STRUCTURES DESIGN BULLETIN C11-07 **ROADWAY DESIGN BULLETIN 11-07**

DATE: June 30, 2011

SUBJECT: Incorporation of Prefabricated Steel Truss Pedestrian Bridges in FDOT Bid Documents

Figure 8.2 Prefabricated Pedestrian Bridge Standard Truss Configurations

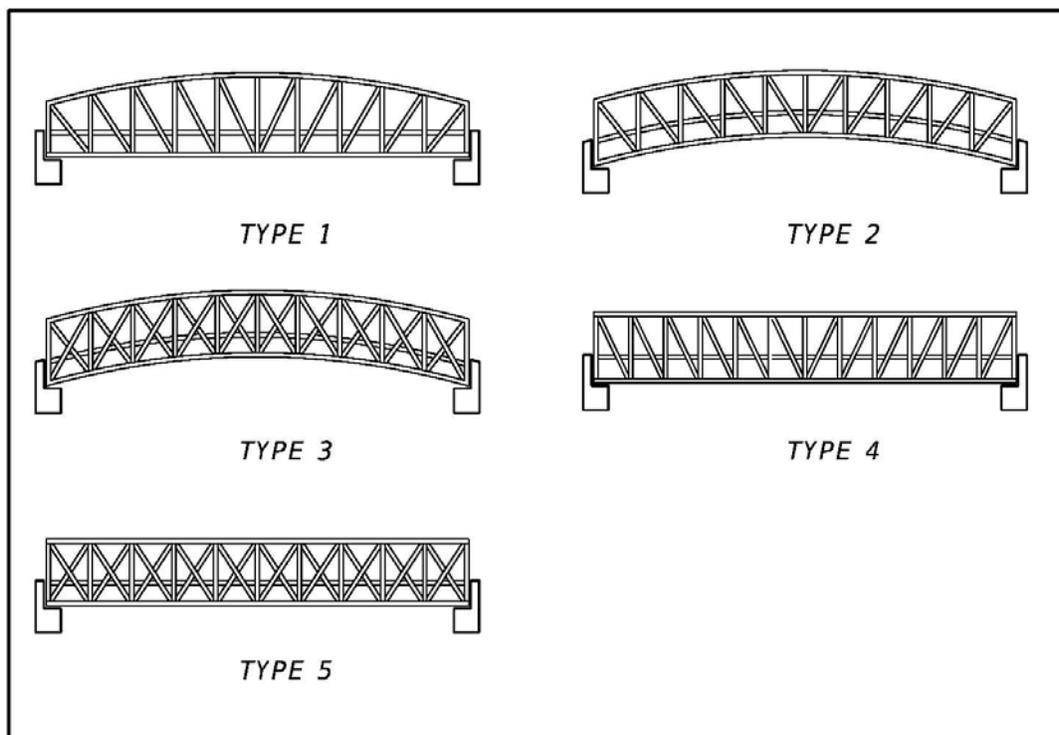
2. Insert sub-article 8.7.2 below Figure 8.1 as follows:

8.7.2 Prefabricated Steel Truss Pedestrian Bridges on FDOT Projects

1. Using Figures 8.2, 8.3, and 8.4, coordinate with the District Project Manager to select all allowable truss configurations, truss member shapes, and bridge cross-sections. Note that for spans greater than 150 feet a box truss bridge cross-section is required.

If project specific aesthetic requirements warrant the use of truss configurations not included in Figure 8.2 the project EOR can specify additional truss configurations. However, a minimum of two steel truss pedestrian bridge producers shall be capable of satisfying the aesthetic requirements.

Figure 8.4 Prefabricated Pedestrian Standard Bridge Cross-Sections

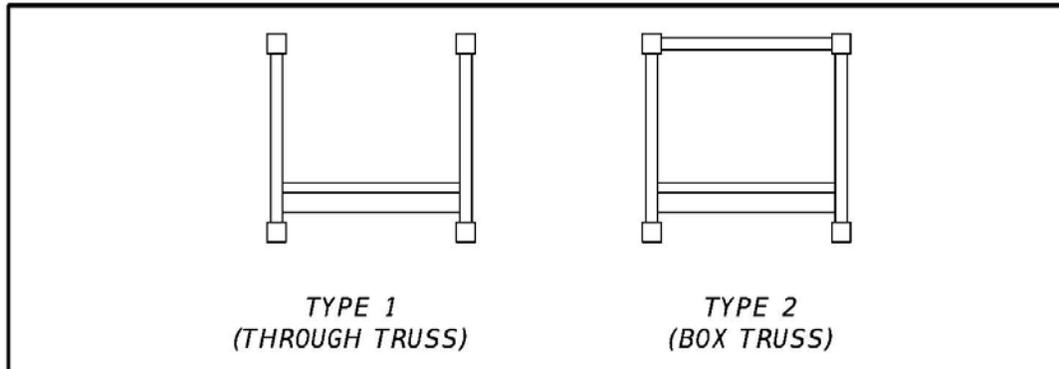
Through Truss is limited to spans lengths less than 150 feet.
